This gallery shows some pictures of bad solderings - they should prevent you from making the same errors (feel free to add even more pictures here!)

From:
<https://wiki.midibox.org/> - **MIDIbox**

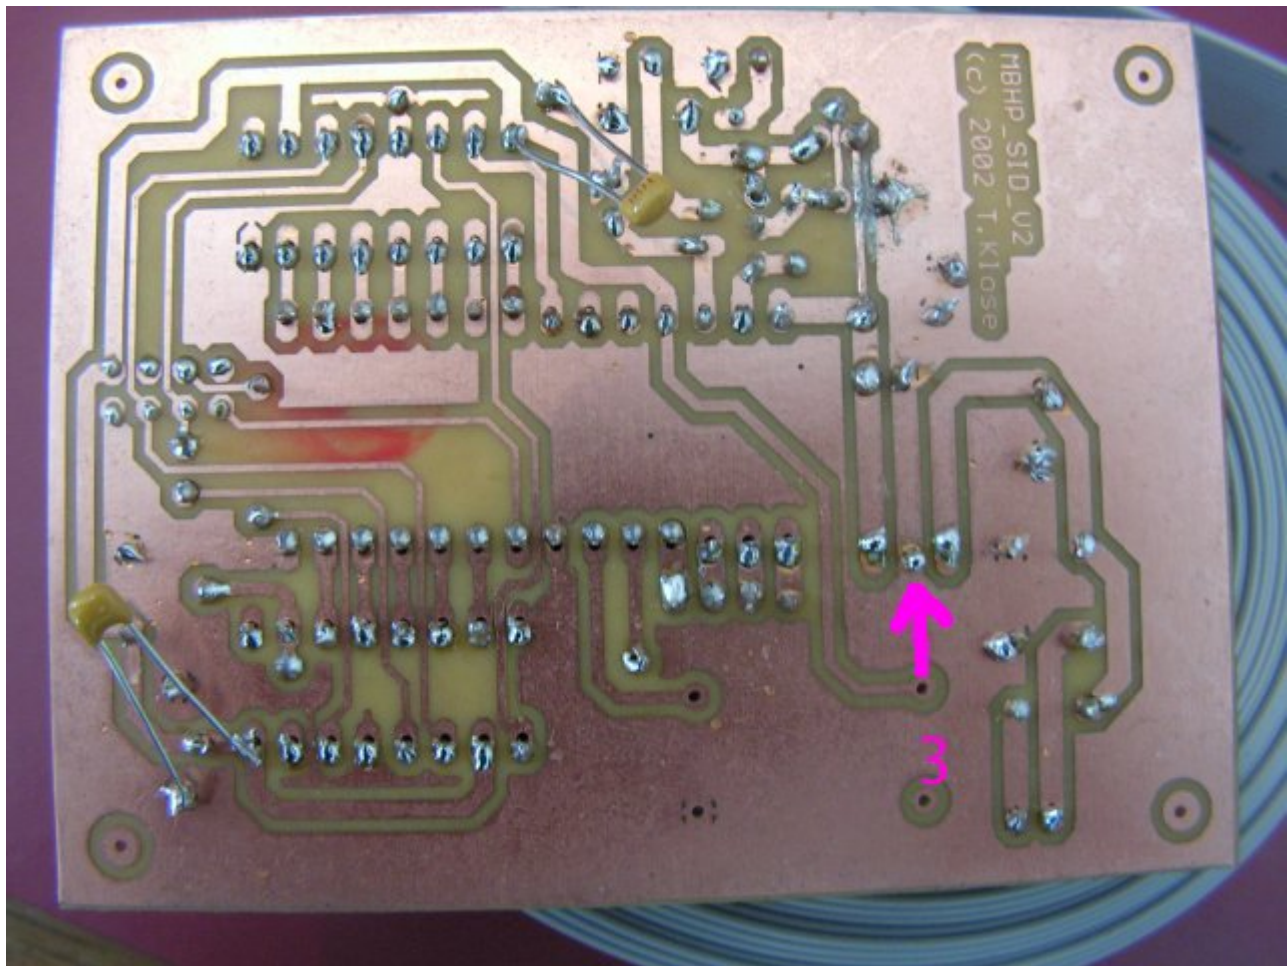
1: the core module has some bad solderings (loose connections), which could lead to failures. There are also missing solderings (e.g. 33pF cap below crystal). It makes sense to solder each pad again, the [Soldering](#) guide in the Wiki gives some useful tips

2: the legs of the caps should be cutted, otherwise they can cause a short circuit which can damage the PIC!

3: this seems to be a bad ground connection directly at the 78xx - it can lead to the wrong voltage. Here the same: just solder the pads again, it will help

And same like above: the long cap legs need to be cutted, the danger for shorts is too high!
